# 33-KILOVOLT POWER LINE NASSRIYA, IRAQ

**SIGIR PA-08-127**  
**JULY 22, 2008**

SUBJECT: Report on Construction of the 33-Kilovolt Power Line, Nassriya, Iraq (Report  
Number SIGIR PA-08-127)

## **33-Kilovolt Power Line, Nassriya, Iraq**

Figure 2. 33-kV power line drawing (Courtesy of the USACE)

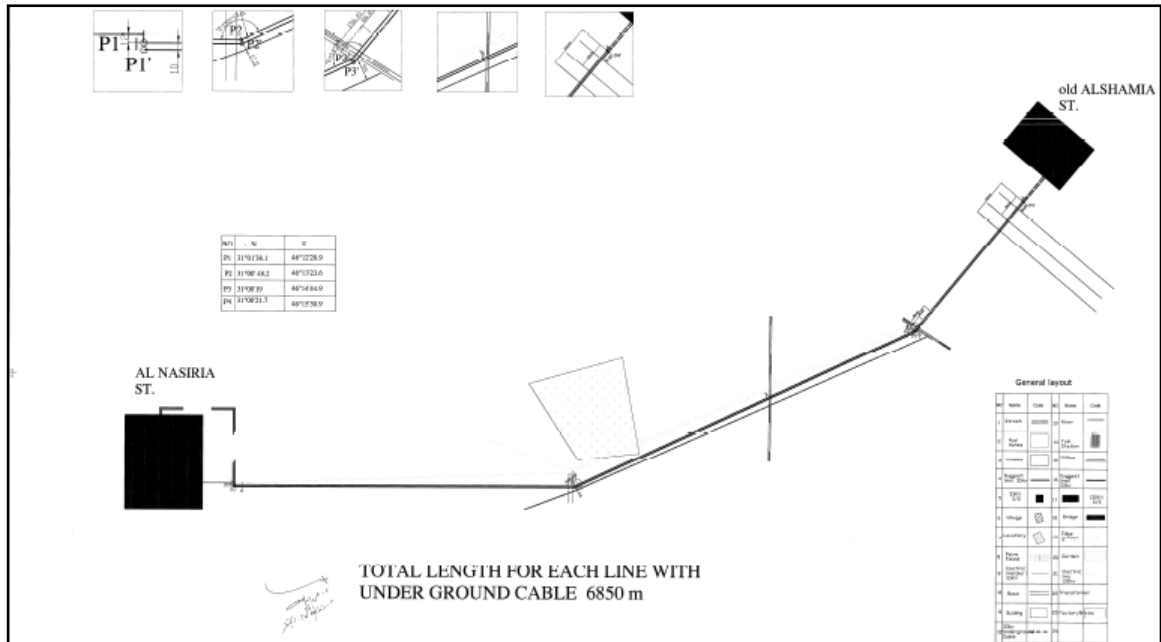
The USACE provided SIGIR with the contractor’s 33-kV power line one page “route” drawing and one profile sheet. The design documents consisted of the route drawing (Figure 2), which provided the total length for each line with underground cable and a profile sheet that determined the height and length between structures. The contractor’s design documents did not provide complete engineering drawings, including construction, civil, mechanical, and electrical, or single line diagrams.

After reviewing the design drawings and specifications supplied, SIGIR determined the design package available was not complete; it lacked sufficient details and did not meet the contract requirements. Specifically, the design documents did not provide any preliminary alignment plans with topographic survey, soil reports, right-of-way plans, construction drawings (which typically includes plan and profile sheets, detail sheets, quantity sheets, and environmental protection plan sheets), structural calculations, foundation calculations, technical specifications, catalog cuts of equipment specified, general design notes with assumptions made, or standard drawings referenced.
